THE ENFIELD CYCLE COMPANY LIMITED

.....25th October, 1960.....19

Replying to your recent memo, the following are suggestions for modifications to the present standard three piece silencer, which we might try with a view to reducing the noise.

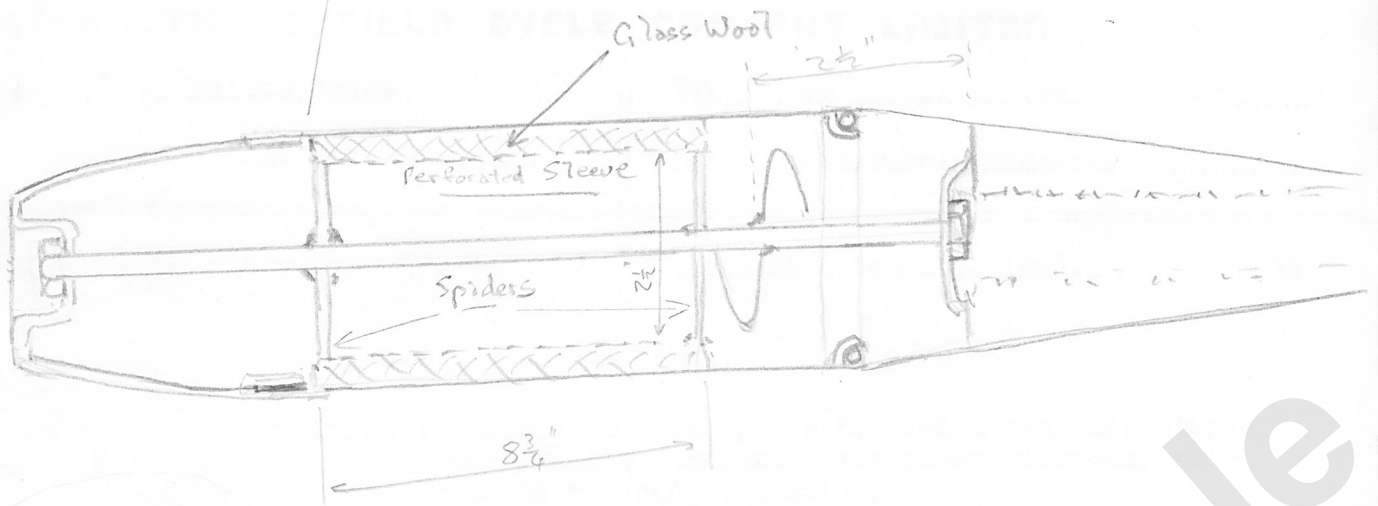
2. Make up a rod with a baffle with its centre $2\frac{1}{2}$ " from front end of rod (i.e. as far forward as possible to miss the nylon seal) and use this in conjunction with a perforated sleeve about $2\frac{1}{2}$ " diameter, and $8\frac{3}{4}$ " long located on spiders on the centre rod. The annular space between this sleeve and the outer case to be packed with glass wool when assembling the silencer, after plating, (See sketch)
